SERVICE BULLETIN

N° **139-704**

ATA 93 - OPLS ELECTRICAL INSTALLATION IMPROVEMENT

This Service Bulletin provides the necessary instructions to improve the OPLS electrical provision P/N 3G9360A00211 or P/N 3G9360A00212. This is done by protecting the laser sensor units connectors on the upper deck with the use of a thermofit sleeve and by replacing their existing fixings on the front firewall in order to avoid chafing of their cables.

**Figure 1**

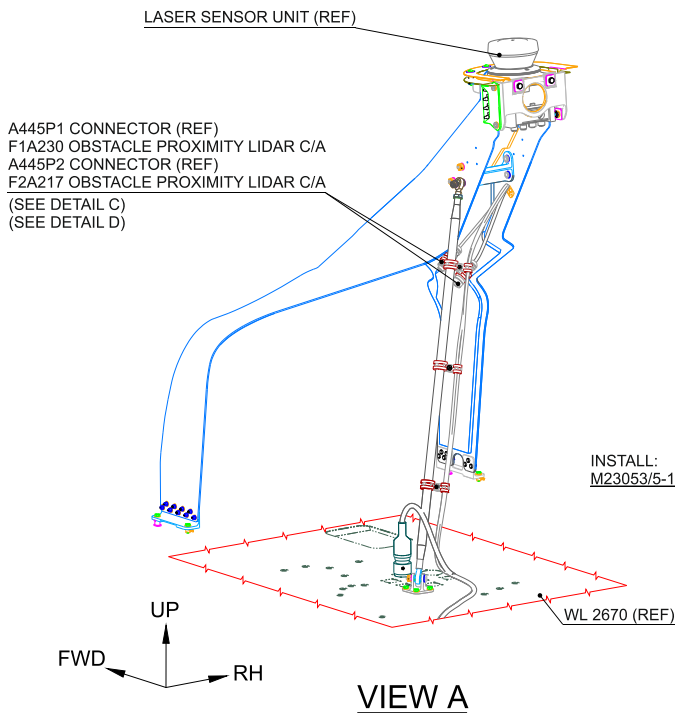
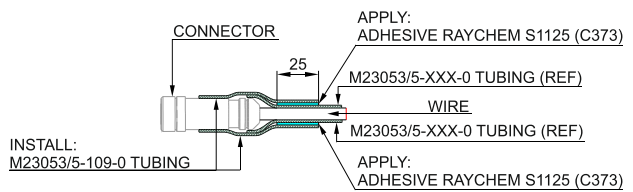
- 2.1 With reference to Figure 1 Detail C, free the connectors A445P1, A445P2, A447P1, A447P2, A446P1, and A446P2 from the stowage.

- 2.8 With reference to Figure 1 Detail C, protect and stow the connectors A445P1, A445P2, A447P1, A447P2, A446P1, and A446P2 by means of nomex P/N EN6049-006-25-5 and tie strap P/N AW001CK03LC.

Figure 2

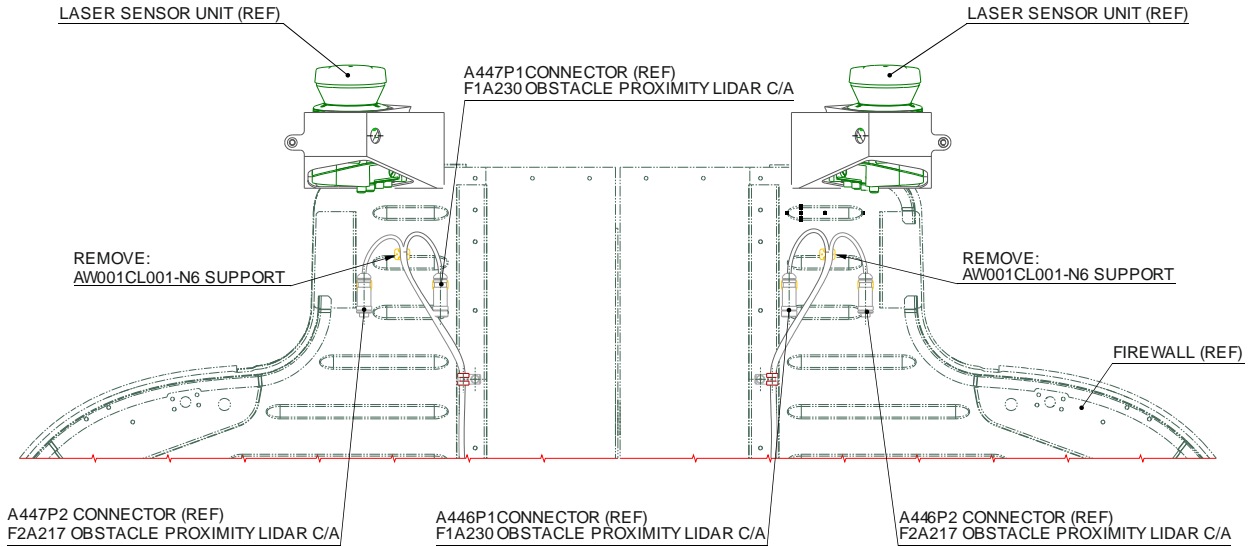
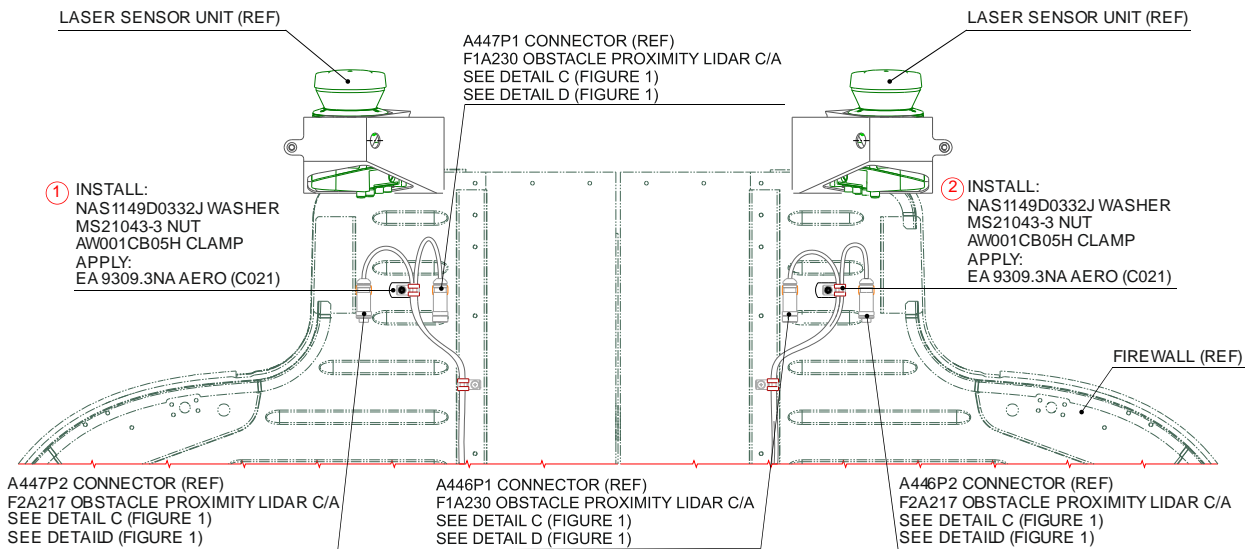
- 2.2 With reference to Figure 1 View A and Figure 2 View B-B Was, disconnect the connectors A445P1, A445P2, A447P1, A447P2, A446P1, and A446P2 from the laser sensor units.
- 2.3 In accordance with applicable steps of AMP DM 39-A-20-10-19-00A-920A-A and with reference to Figure 2 View B-B Was, remove n°2 supports P/N AW001CL001-N6 from the firewall.

- 2.4 In accordance with applicable steps of AMP DM 39-A-20-10-09-00A-920A-A and with reference to Figure 2 View B-B Becomes, install n°2 stud P/N A366A3E10C75 on the firewall by means of adhesive EA 9309.3NA AERO (C021).
- 2.5 With reference to Figure 2 View B-B Becomes, install n°2 clamps P/N AW001CB05H on the C/A F2A217 and C/A F1A230 by means of n°2 washers P/N NAS1149D0332J and n°2 nuts P/N MS21043-3.
- 2.6 With reference to Figure 1 Detail D, protect the connector A446P1 by means of one piece of tubing P/N M23053/5-109-0, covering also the wire with an overlap in accordance with the dimensions shown, and bond it by means of adhesive Raychem S1125 (C373).
- 2.7 Repeat the previous step 2.6 for the connectors A445P1, A445P2, A447P1, A447P2, and A446P2.

INSTALL THE STUDS REPORTED IN TABLE BELOW:

LOCATION NUMBER	P/N	STA	BL	WL	ORIENTATION
①	A366A3E10C75	5747	283	3456	90°
②	A366A3E10C75	5747	-275	3456	90°
